Access Compliance Report

Public Rights-of-Way

(Curb Ramps)

Intersection ID: N/A	Main Street: CRESSWIND BV	Cross Street: SHOFF CIR	Location: S
ADA ID: 1C3C762DB114	Ramp Type: BlendTrans1	Initial Pass/Fail: Fail	Overall Compliance: No
Severity Score: 25			
Codes/Mitigation Info/Possible Solution		Field Measurements/Component Compliance

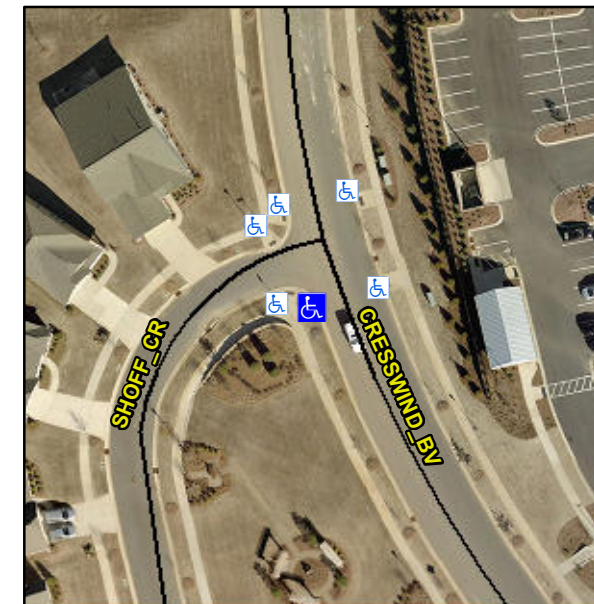
Remove & Replace Curb Ramp With Two New Directional Ramps or Equivalent.

Not Found, R304.5.3
